RESIDENTIAL DEVELOPMENT WITH IN-FILL AFFORDABLE HOUSING AT 59-63 TRAFALGAR AVENUE AND 1A AND 1B VALLEY ROAD, LINDFIELD

SSD 79276958

ATTACHMENT - REASONS FOR OBJECTION

Photos looking from the beginning of the creek at 32 MHR east towards 32A MHR

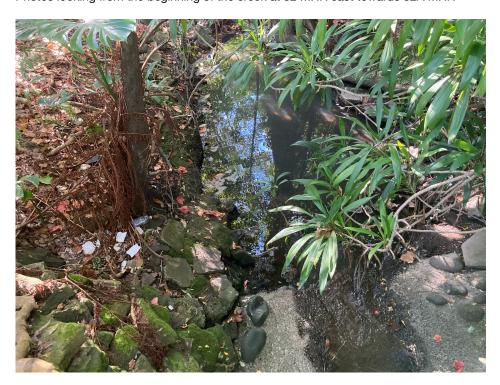
As demonstrated by the photos below, Gordon Creek and the associated Riparian Zone actually commence at 32 Middle Harbour Road, and rather than a dry gully, there is a flowing stream with significant vegetation that is home to species including birds, frogs and water dragons.
